CPRM February 28, 2023 PL-17-23 Staff Presentation

Item 5.2-2222 Lakeshore Road Community Heritage Fund grant application (PL-17-23)

Community Planning Regulation & Mobility Committee Meeting February 28, 2023

Community Heritage Fund Rules:

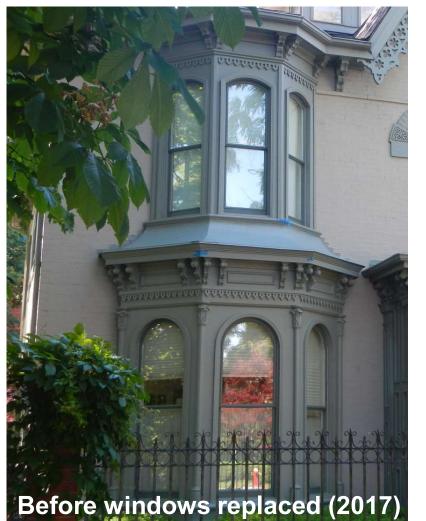
- ✓ Proposed Grant amount is for no more than 25% of total project cost and does not exceed \$15,000
- X Scope of work relates to elements specified in designation bylaw
- X No modern doors or windows (ie. Windows or doors that are not replicas of the original in like materials)
- ✓ At least 3 quotations for the work are included in the application
- Name, address and contact information of qualified contractor is provided
- ✓ Contractor performing work is licensed
- Photos, drawings and specifications included

Decline Halton Condominium Corporation 141's Community Heritage Fund grant application for a \$15,000 grant to subsidize the replacement of all windows at 2222 Lakeshore Road with modern vinyl windows, due to non-compliance with Community Heritage Fund criteria.
